ATTACHMENT 1

PROPOSED TECHNICAL SPECIFICATION CHANGE

NORTH ANNA UNIT NO. 1

Figure 6.2-1 Offsite Organization for Facility Management and Technical Support

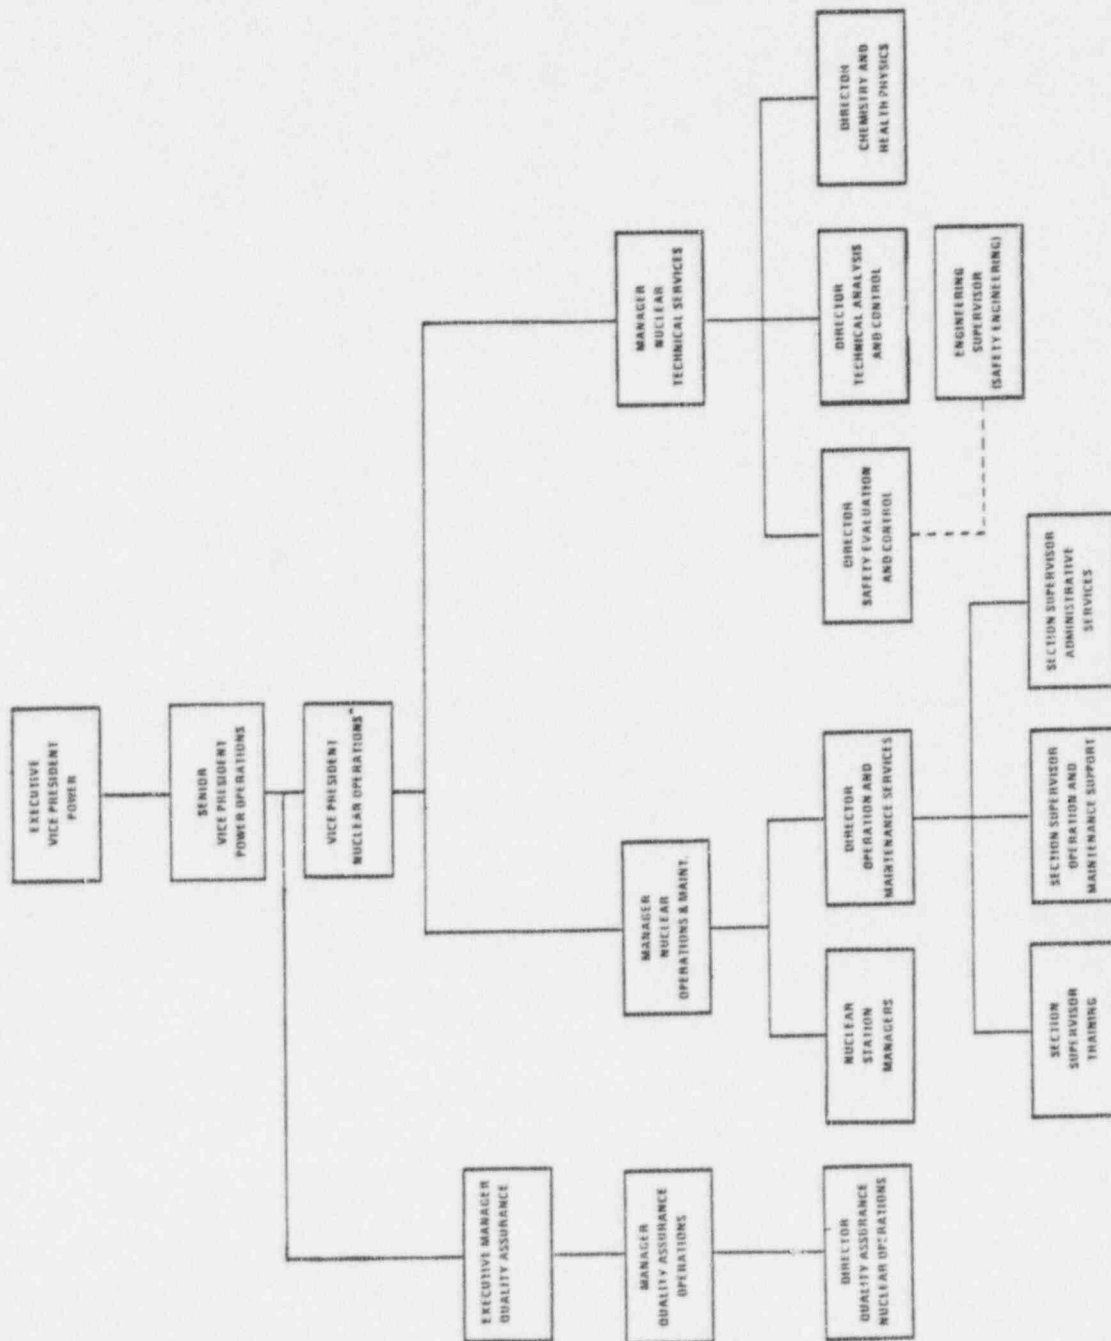
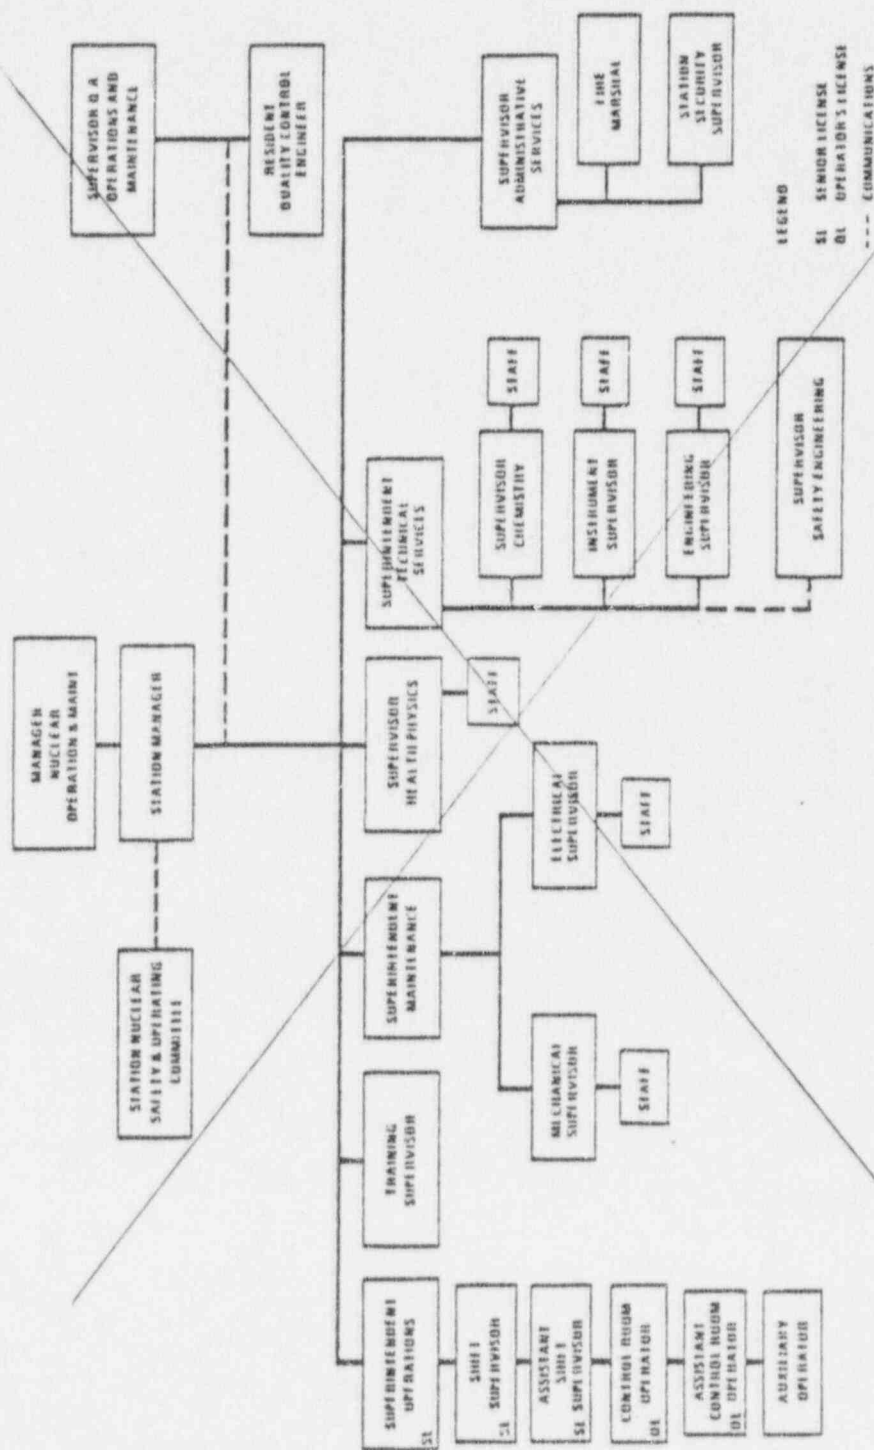
SEE ATTACHED PAGE

Figure 6.2-2 Facility Organization - North Anna - Units 1 and 2

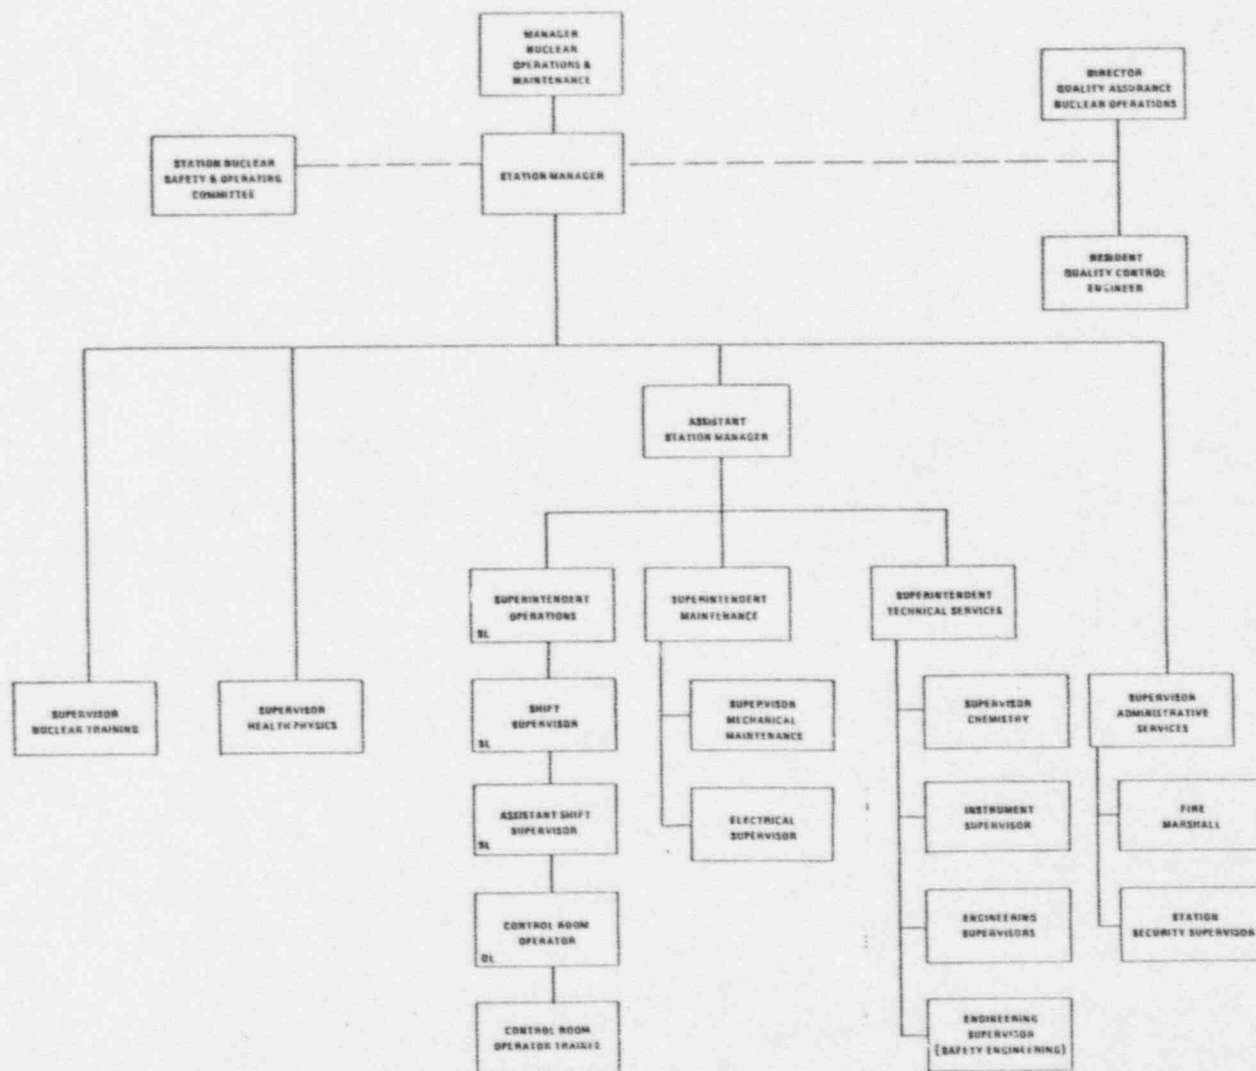
SEE ATTACHED PAGE
